RE: Responses to Questions and Comments raised in Connection Ashland Rail Transit Apartments

Re: SUPPLEMENT NO.1 Ashland Rail Transit Apartments -Response to Comments from:
Design Review Committee Public Meeting held December 1, 2015.

EXHIBIT A CROS-SECTIONS FROM HIGH STREET TO BUILDING #7 12.28.15

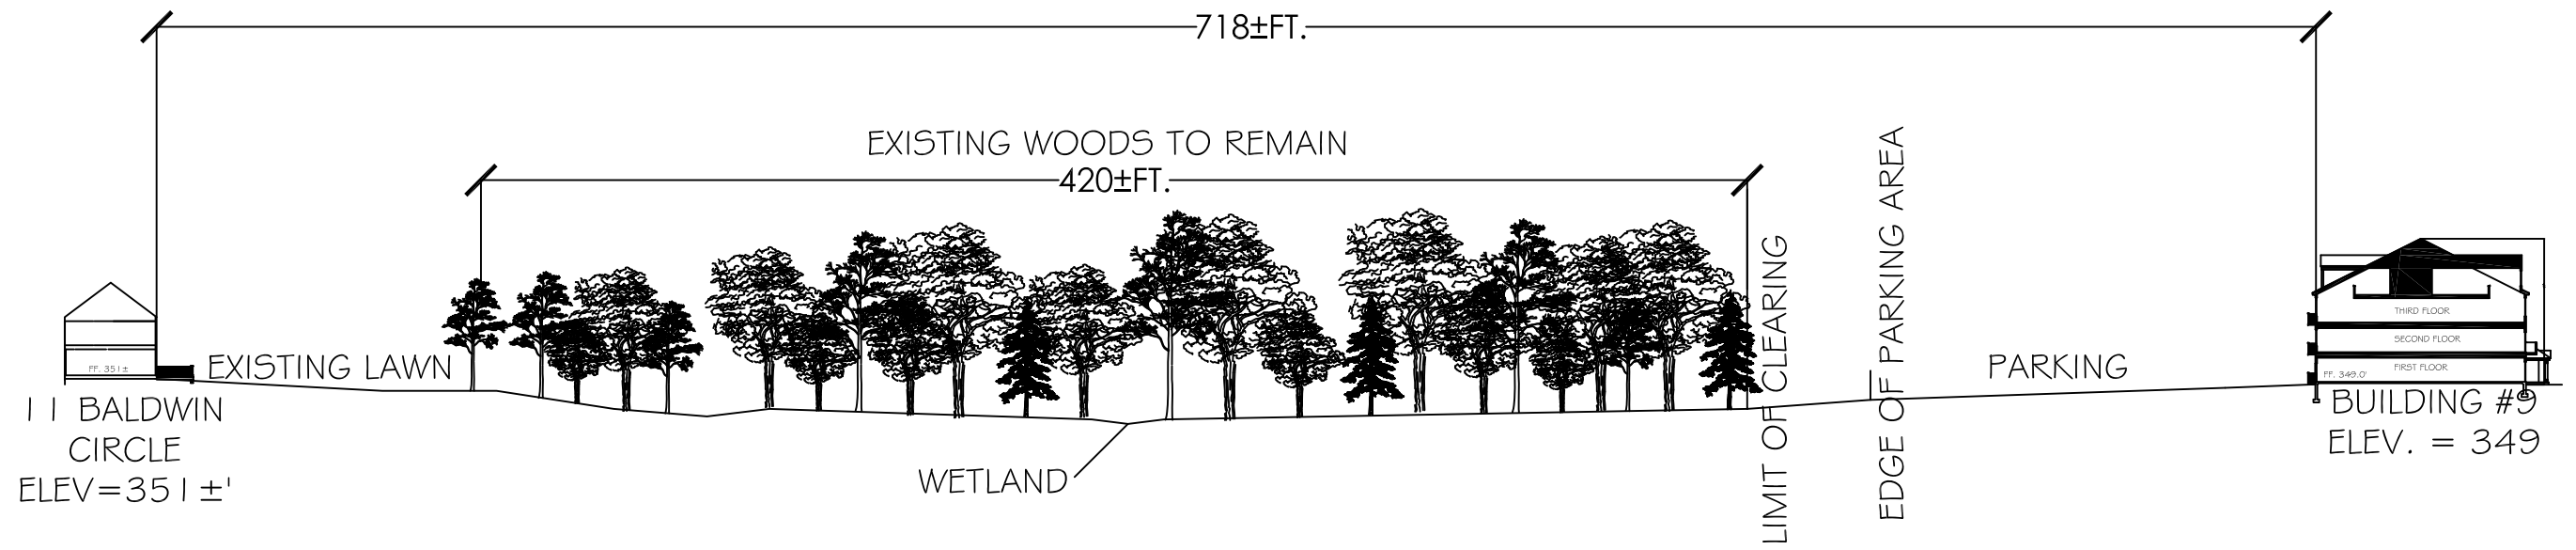
11. Will the apartments be visible from High Street. There are no plans to alter the land near high street with the exception of the emergency access road. The resident requests a drawing /view of the apartment complex from High Street. The developer suggests flagging the corner of the building and the edge of clear cutting on the site as an alternate to the drawings. The resident is open to this solution.

13. Would like to see topography plans - Existing vs Proposed to determine if buildings will be visible from High Street. . The current presentation is schematic only.

Response: Yes they will be visible from High Street as least on a seasonal basis. Exhibit A shows the cross-section from High Street to the closest Residential Building (Building #7). Most of the vegetation to remain is deciduous which becomes relatively transparent in the winter. Exhibit B shows the relationship between 106 High Street and the Proposed Community.

Response: Exhibit A shows the relationship between High Street and Building #7. The building that faces High Street is 3 stories in the front and 4 stories tall on the back. The 4 story façade will face High Street. Exhibit B shows the relationship between 11 Baldwin Circle and the Proposed Community.
